Victa

SERVICE BULLETIN NO. 13

SUBJECT: Redesigned tailplane to fuselage attachment fittings. MOD. NO. B.53

EQUIPMENT AFFECTED: All Airtourer 100 and 115 aircraft.

FIG. 1

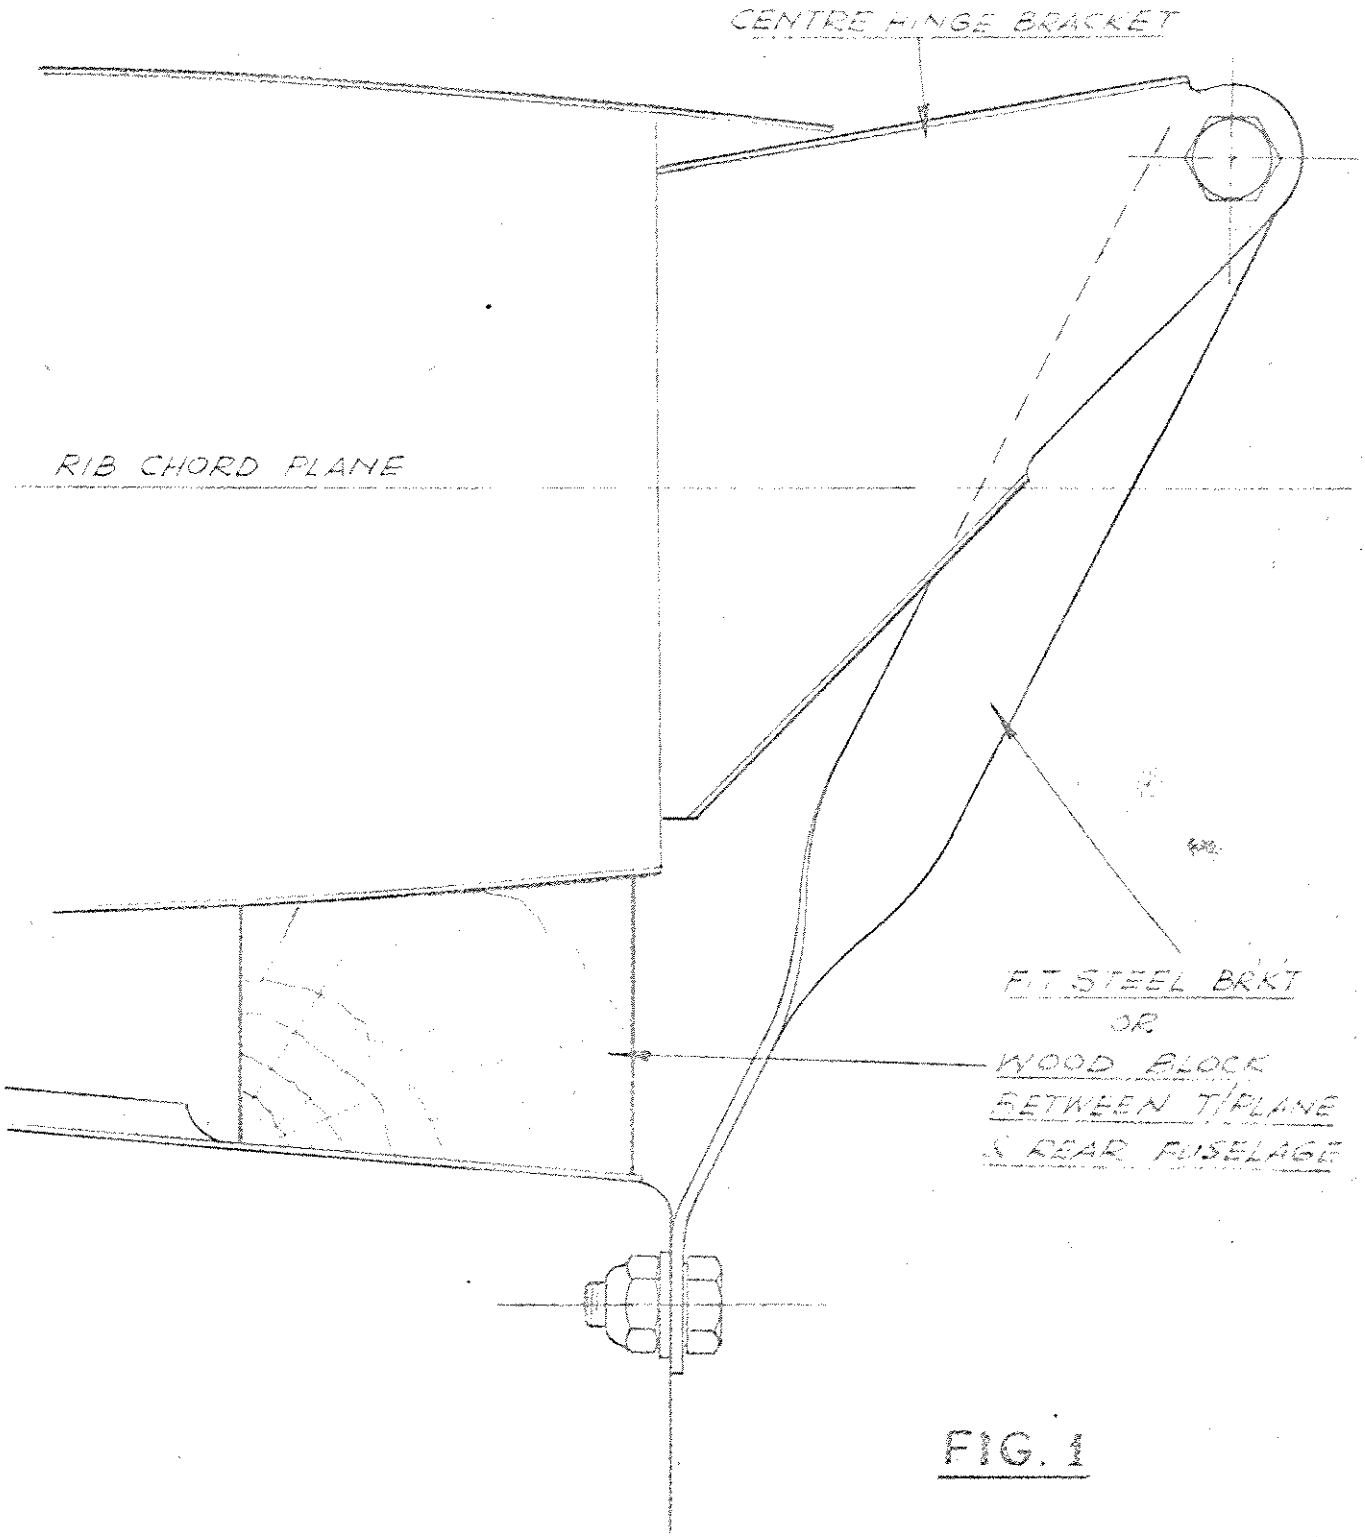
(i) Place a block or wedge between the rear fuselage and the tailplane in the vicinity of the rear frame and the tailplane spar. See Fig. 1.

(ii) Make up a steel bracket to pick up between the top centre tooling hole in the rear frame and the hole in the elevator centre hinge bracket. See Fig. 1.

DETAIL 'A'

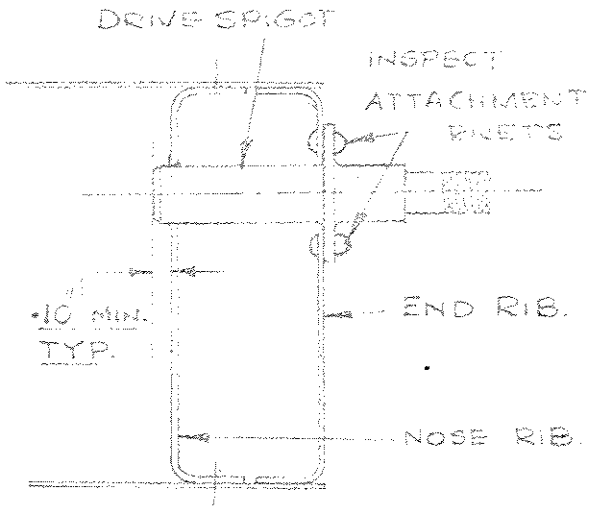
Immediate inspection of the drive spigot attaching rivets on the inboard ends of the ailerons and the outboard ends of the flapperons is advised. (Refer Detail A). If the rivets show signs of working then a further internal inspection of the spigot to determine the amount of penetration through the nose rib will be necessary before the next flight. A minimum of .10" total penetration of the spigot through the nose rib is required. (See detail A). (If no signs of working are apparent then further internal inspection can be deferred until the next 25 hourly inspection).

DETAIL 'B'

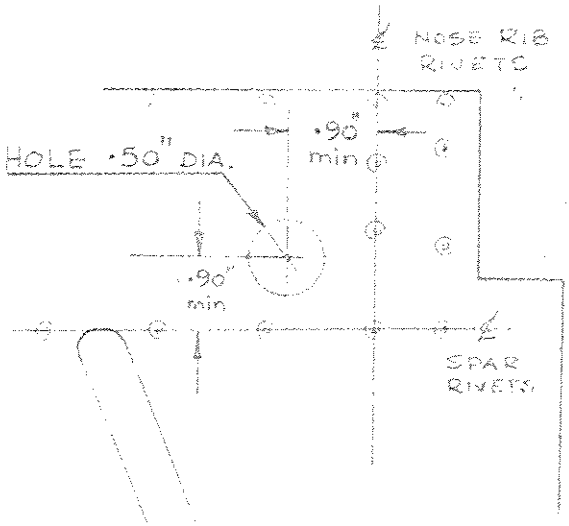
To accomplish internal inspection, drill a hole .50" dia. in upper surface of ailerons and flapperons as shown in Details B and C respectively, and with the aid of a flashlight ascertain degree of penetration of spigots. If penetration is less than .10" inform Victa Limited, Aviation Service Department and a new longer spigot will be despatched.

UPPER SURFACE OF AILERON.
(PORT SHOWN - STBD SIMILAR.)

DETAIL 'D'

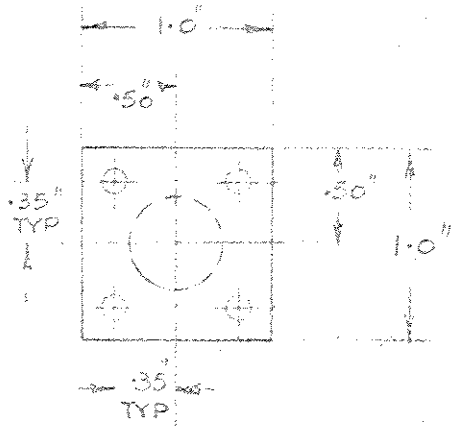
After inspection, cover hole with 28 swg. cover plate and rivet with Tucker 'Pop' rivets as shown in Detail D.

COVERPLATE - MAKE FROM
28 SWG AL. ALLOY SHEET.

Fig. 1

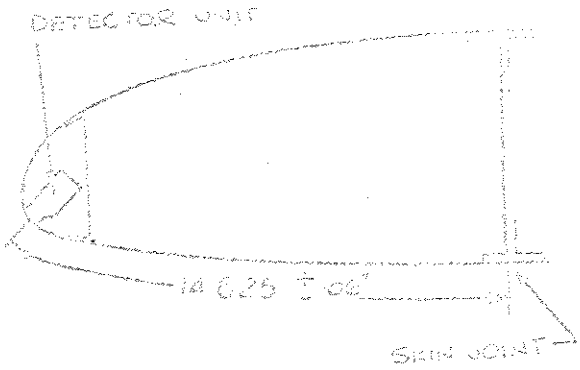
1. A check on the position of the detector vane around the profile may be obtained by measurement along the contour between the bottom edge of the vane and the skin join on the bottom surface of the spar, refer Fig. 1.

Because the detector is at the mid-point of [illegible] adjustment when measuring. The position of the skin join is not fixed however, production techniques [illegible] and [illegible] that it may be used as a reliable and easy check on the [illegible] to position the detector as shown on Victa Drg. No. 02-03076.

Fig. 2

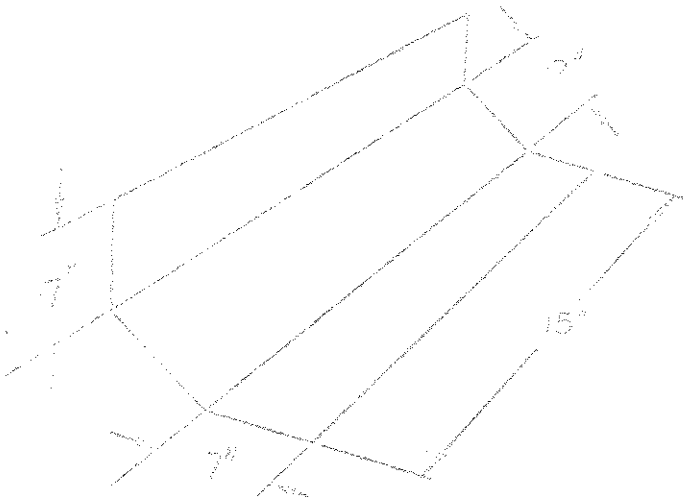
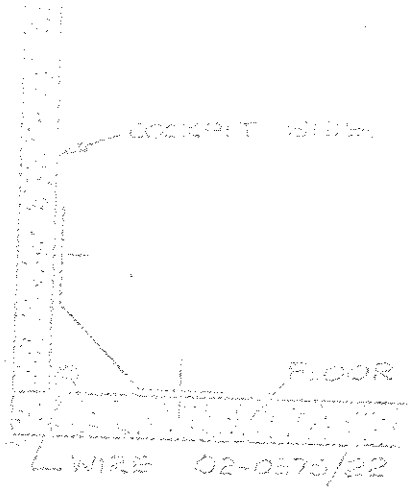
4. [illegible] wire, [illegible] No. 02-0270, [illegible] rubber to the area where it runs along the seat floor [illegible] be fitted by a guard as shown. Refer Fig. 2 & 3. Drill [illegible] at or 24 0150 diameter holes, and rivet a piece [illegible] the floor and cockpit side using 3 pop rivets at 3" pitch.

SERVICE BULLETIN NO. 27

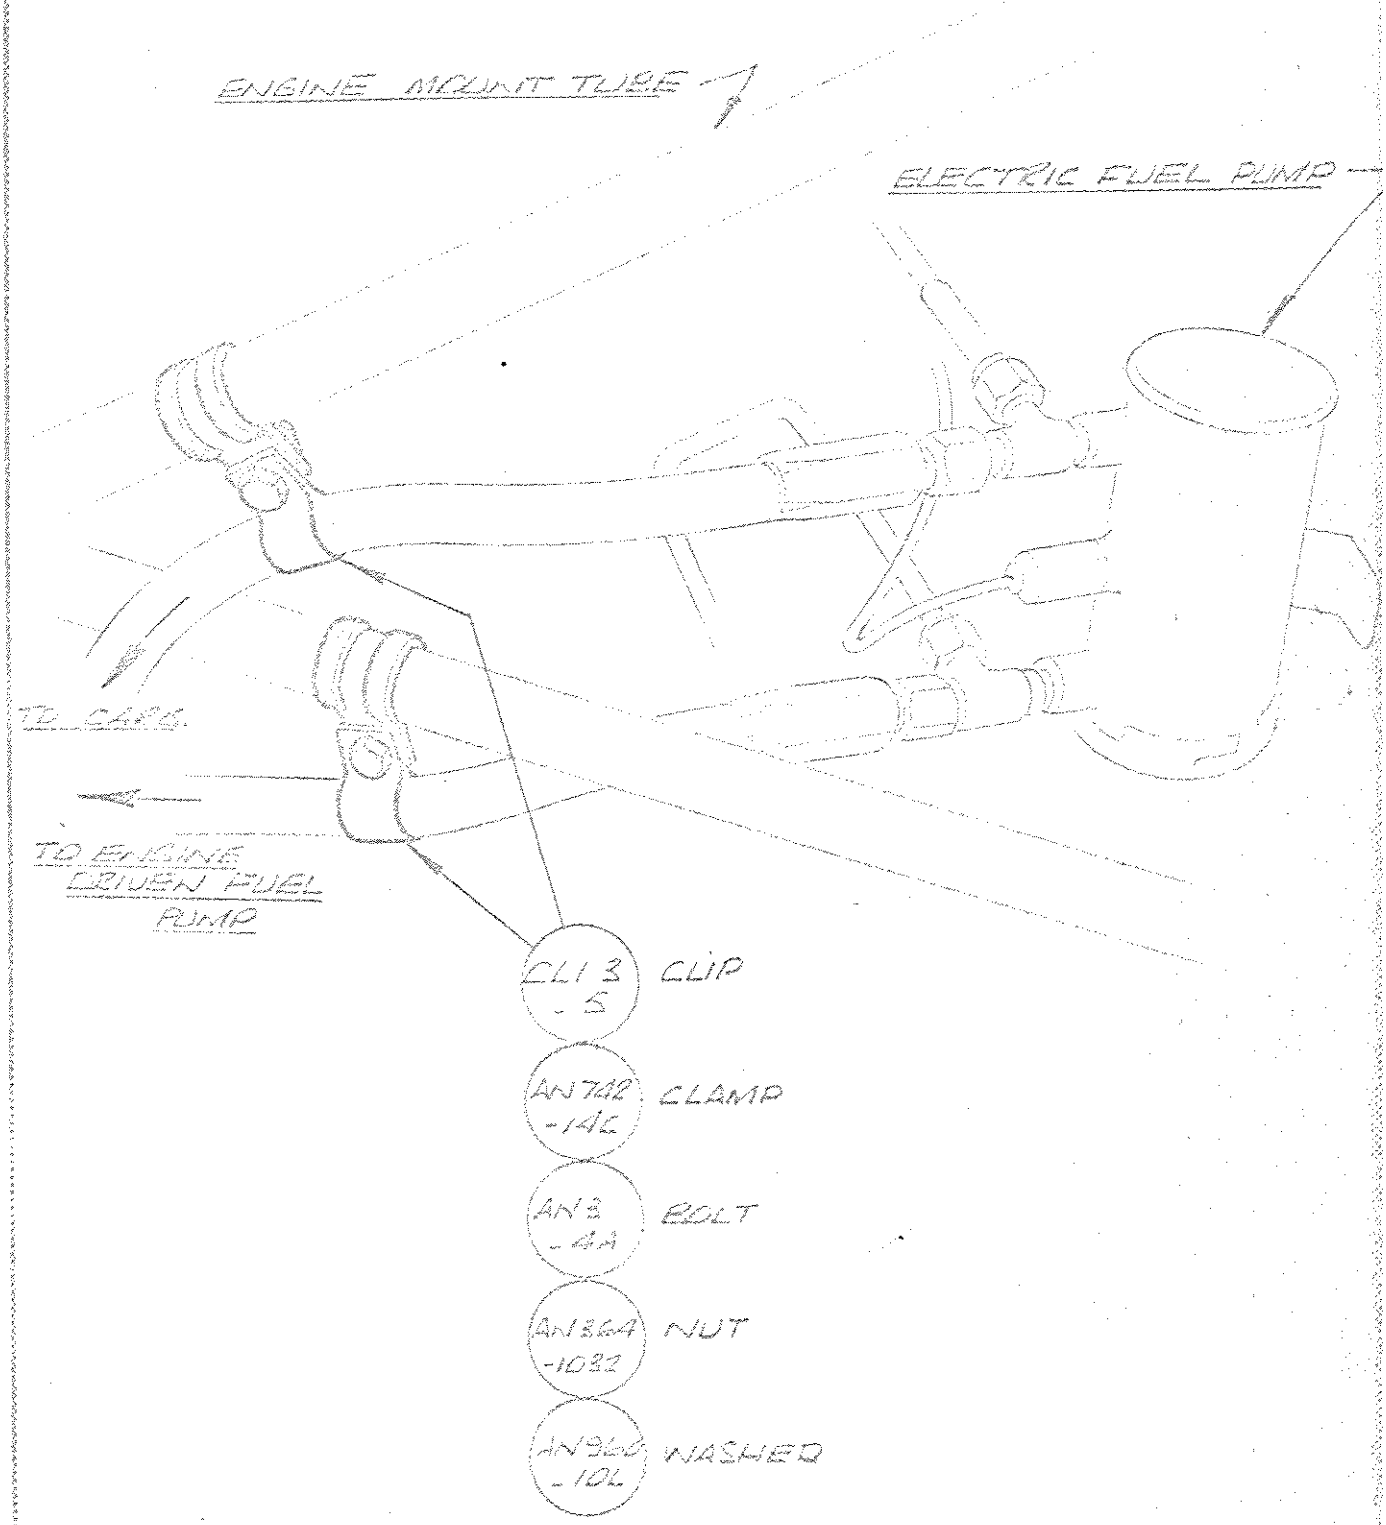
DETAILS: (a) Remove plastic strap beinding flexible fuel lines to port engine mount.

(b) Instal new metal clips in accordance with sketch avoiding sharp bend radii and kinks in the flexible lines.
